Technical Service Information

THM 4L60 (700-R4) TEMPERATURE SWITCH ADDED

Figure 1

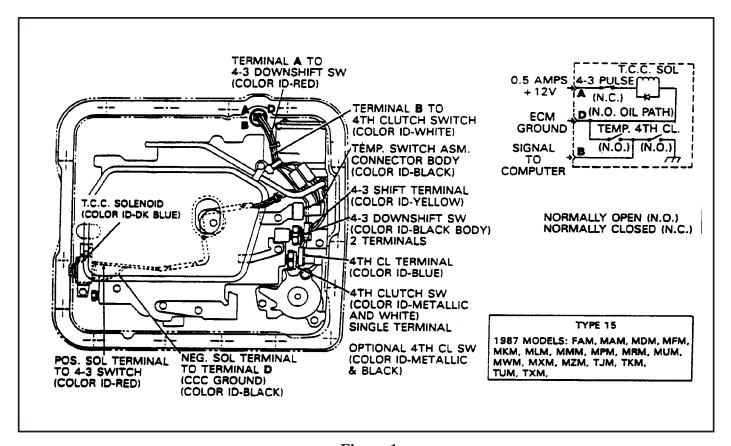
Beginning July 17, 1986, Julian Date 1987, for 1987 THM 700-R4 transmissions, a new solenoid and wiring harness (Type 15) went into production, along with a new temperature switch and bracket assembly (see Figure 1).

The new temperature switch is designed to prevent the transmission from over-heating by applying the torque converter clutch (TCC) under certain conditions. With the gear selector in "D" and the transmission operating in fourth gear, the temperature switch is normally open. If the transmission is operating in fourth gear without TCC apply and the fluid temperature reaches 275"F, the switch closes. When the switch is closed, the torque converter clutch is applied to allow the fluid to cool to 246"F, at which time the switch opens and normal TCC operation resumes.

The new temperature switch is mounted on the control valve assembly by an existing bolt and can be serviced by removing the oil pan
